Appln No. 09/654,376

Amdt date January 5, 2005

Reply to Office action of October 5, 2004

REMARKS/ARGUMENTS

FIG. 14A

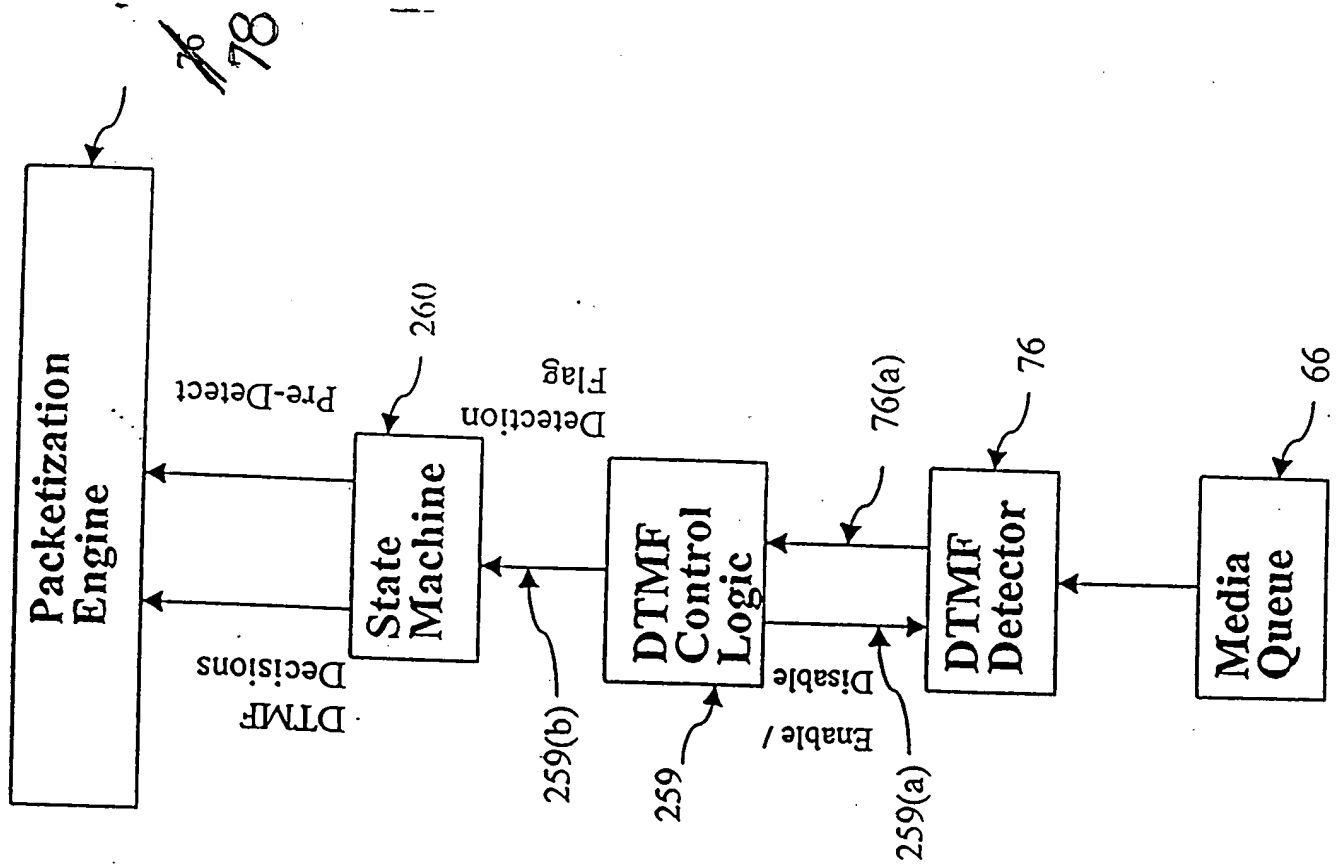
Applicant has amended FIG. 14A to update the reference number to packetization engine to conform with the specification as well as FIG. 6. Specific support for the amendment can be found on page 16, line 27. Therefore, no new matter has been added.
